GENERAL BULLETIN GB2025006
CMD.CTRL™
ROUTING UPDATE

Subject:	CMD.CTRL™ Routing Update
Attn:	IMT Distributors
From:	IMT Sales Team
Date:	November 11, 2025
Affected Models:	All Dominator® Models

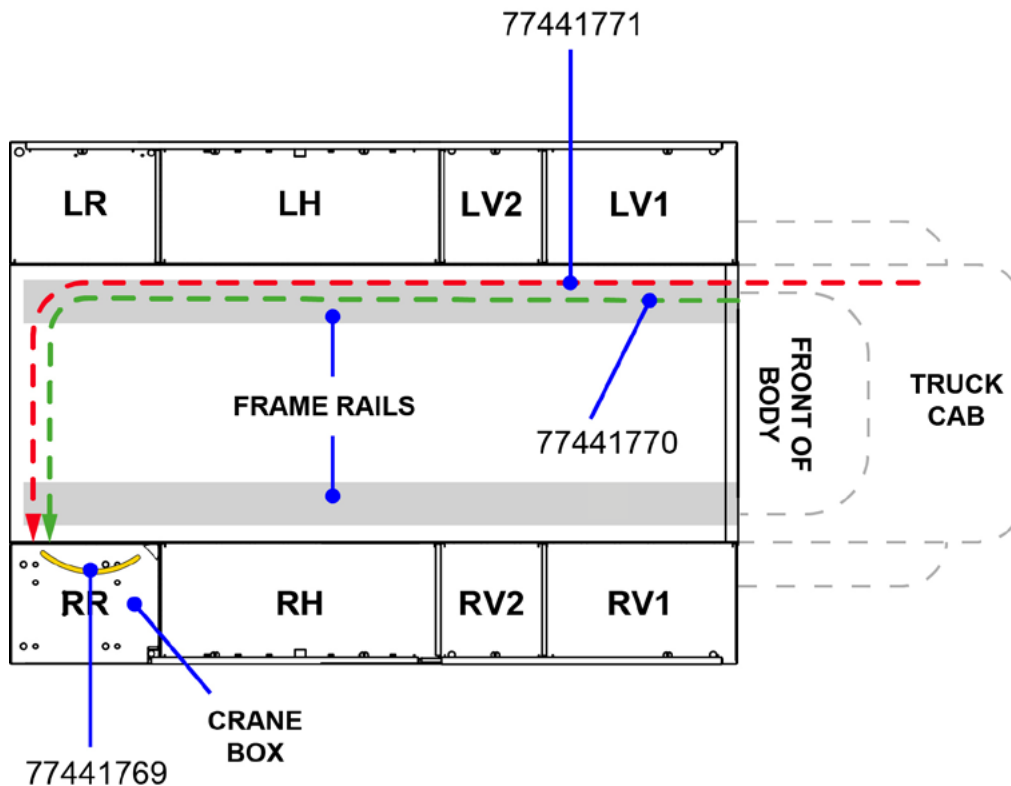
IMT is updating the location of the CMD.CTRL™ panel wiring plug for improved installation and serviceability.

Previously, the body harness was connected to the chassis harness at the front of the body. Going forward, it will connect behind the crane box. To support this change, the chassis harness has been split into two parts: a chassis harness and a compressor and grounding harness, both routed along the chassis frame rails to the crane box.

The CMD.CTRL™ panel harness has been shortened and will now be installed inside the crane box, similar to the previous front bulkhead installation.

This change allows both harnesses to be installed before the body is mounted and ensures easy access afterward if needed.

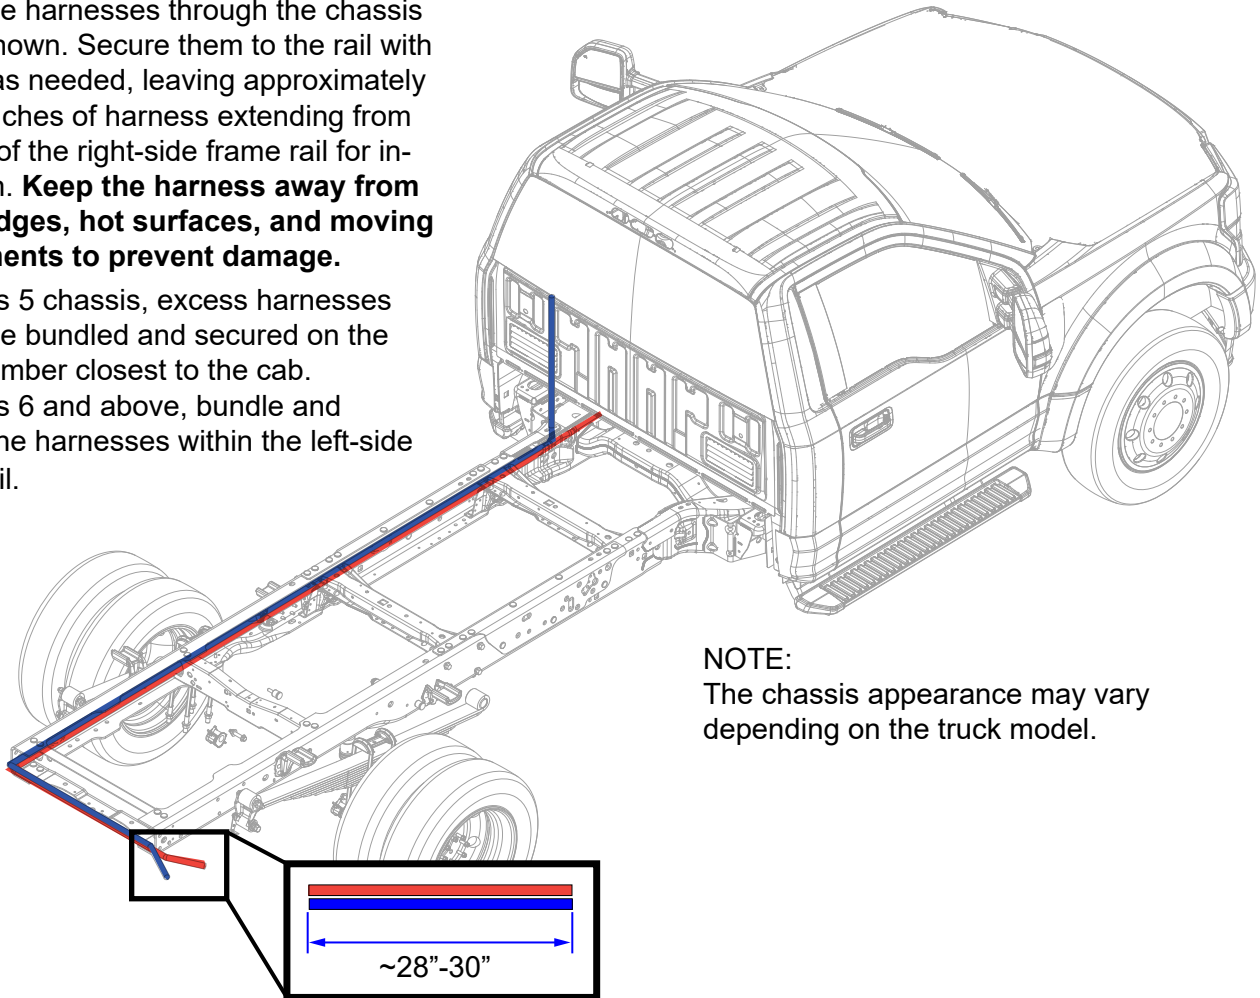
Route the harnesses through the chassis rail as shown. Secure them to the rail with zip ties as needed, leaving approximately 28–30 inches of harness extending from the end of the right-side frame rail for installation. **Keep the harness away from sharp edges, hot surfaces, and moving components to prevent damage.**

On Class 5 chassis, excess harnesses should be bundled and secured on the crossmember closest to the cab.

On Class 6 and above, bundle and secure the harnesses within the left-side frame rail.

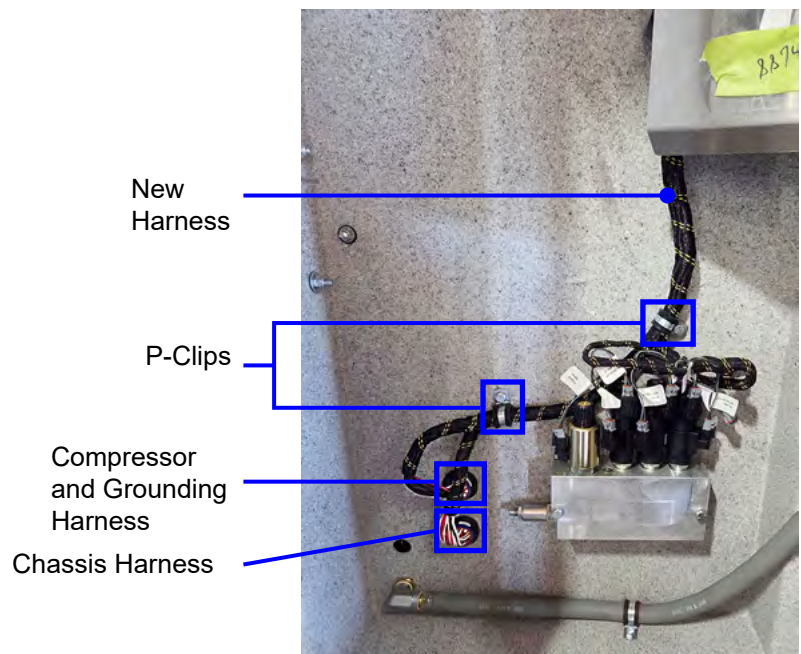
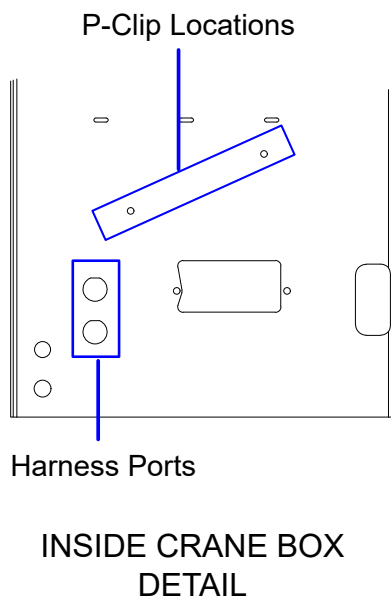
- To replace the 77441741 (or 77441719) body harness, all 3 new harnesses are needed. 77441769 will be used to rewire the control panel. 77441770 and 77441771 will be used to rewire the chassis to be compatible.
- 77441770 connects the body behind the crane box to chassis, grounds and compressor. Harness is mounted in the chassis frame rail.
- 77441771 connects the body behind the crane box to the chassis, similar to harness 77441668. Harness is mounted in the chassis frame rail.

When installing the three new harnesses, two 1 3/4" holes will need to be drilled into the crane box as shown below, with optional 7/16" holes for wire routing.

**44H/52H
Hole Pattern**

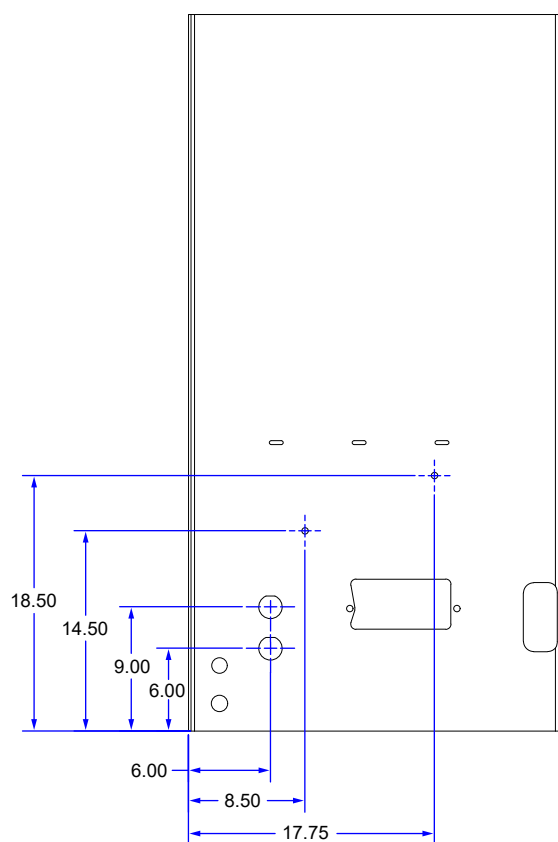
44H and 52H crane boxes will have the same dimensions, while the 60H will have its own unique dimensions. **See the hole pattern details on page 4.**
